SUBJECT: REVIEW OF BROWNS FERRY NUCLEAR (BFN) PLANT, UNIT 2 - TVA
BFN TECHNICAL SPECIFICATION NO. 254 (TAC 00450)

BROWNS FERRY NUCLEAR PLANT (BFN) - TVA BFN TECHNICAL SPECIFICATION NO. 254

ENCLOSURE 2
DESCRIPTION, REASON AND JUSTIFICATION FOR CHANGE
BROWNS FERRY NUCLEAR PLANT (BFN)
UNIT 2

Figure 3.5.K-1 -
MCPR Limits for P8 X 8R/8 X 8R/ QUAD+

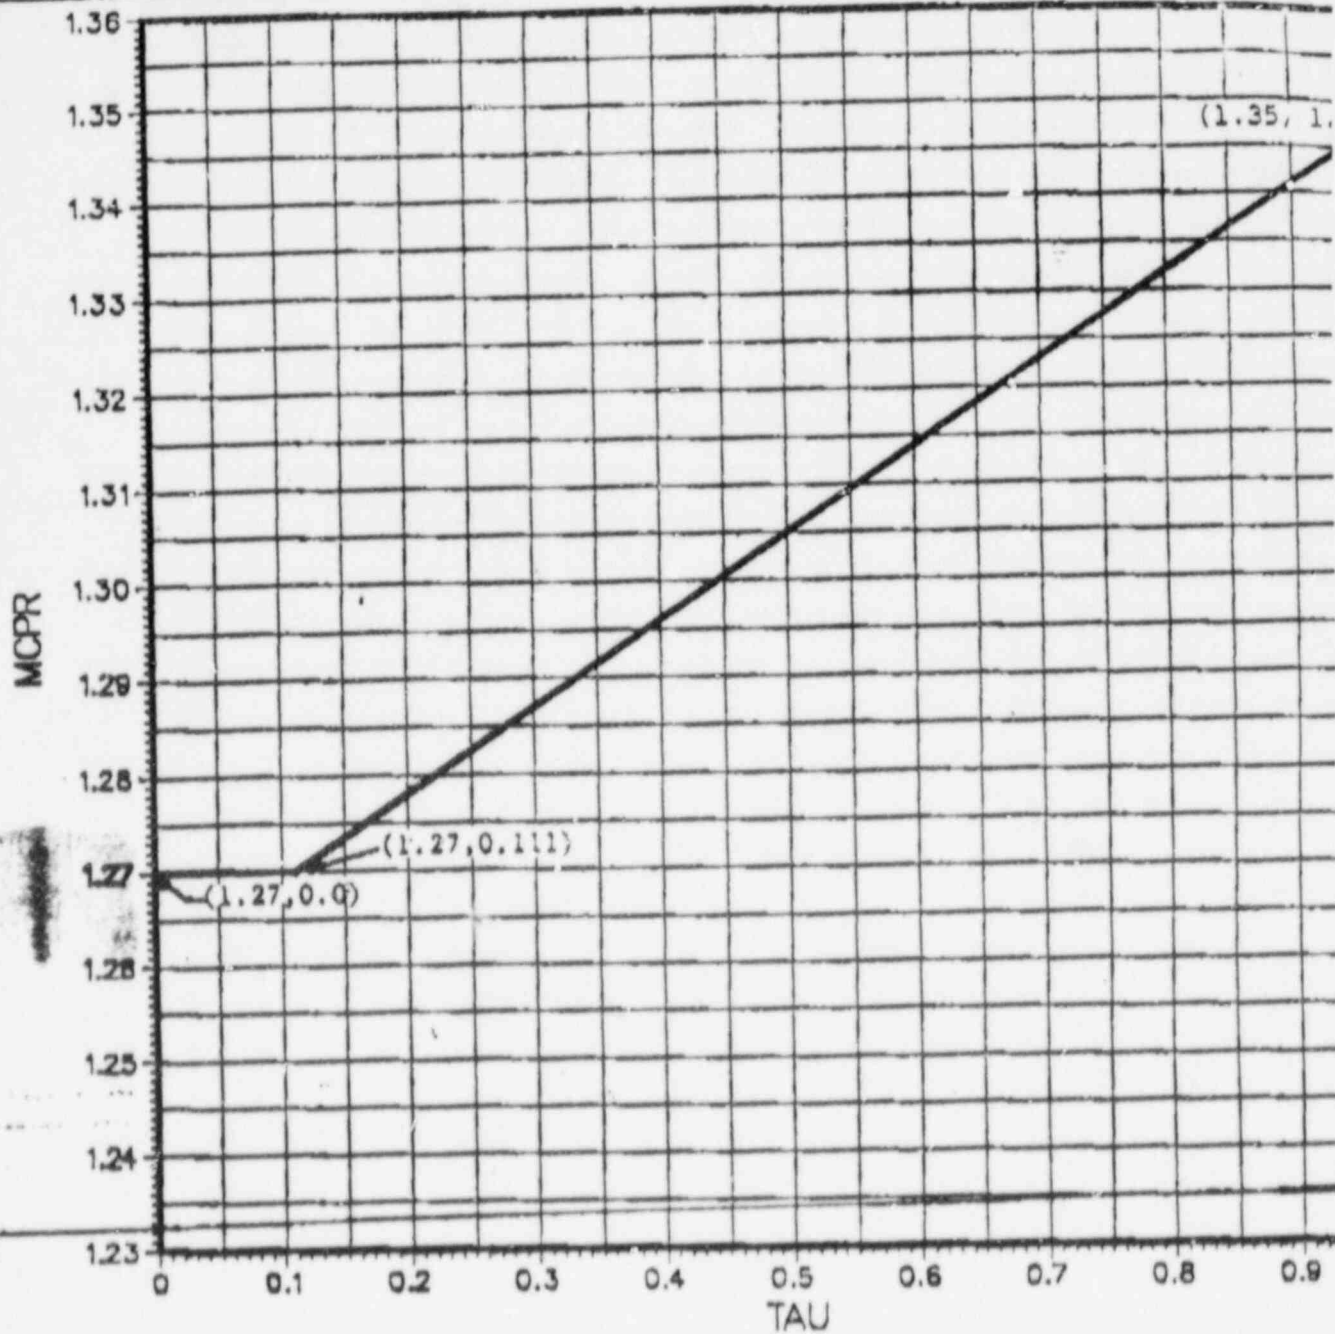
The Minimum Critical Power Ratio as a function of scram time (figure 3.5.K-1) has changed because of the reanalysis performed to include BFN Unit 1 fuel in the Unit 2 reload.

Figure 3.5.K-1 MCPR vs TAU is changed because of the reanalysis. The reanalysis indicated the bounding accidents are rod withdrawal error and generator load reject without bypass. All of the accidents and the bounding envelope are shown in figure 14 of the Reload Licensing Report.

Figure 3.5.K-1

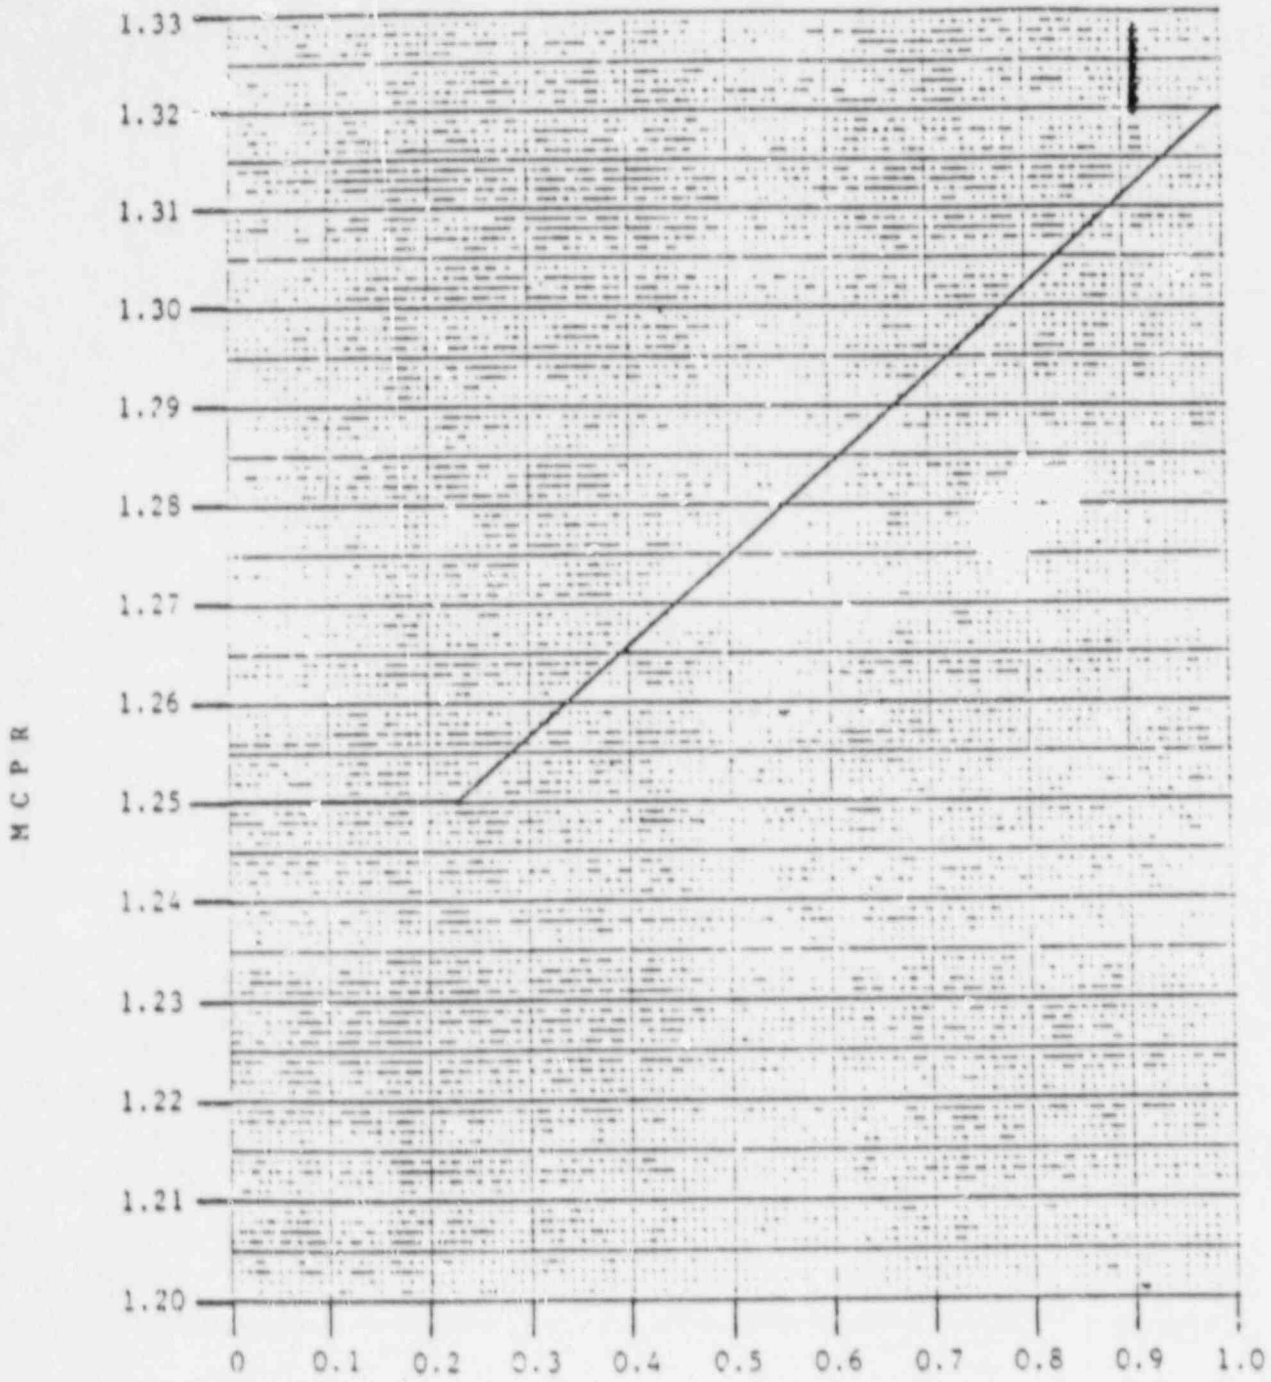
The operating limit MCPR as a function of average scram time, τ , has been altered to account for the Cycle 6 reload. The proposed curve (Figure 3.5.K-1) is consistent with the value given in the reload report (Reference 1) and is acceptable.
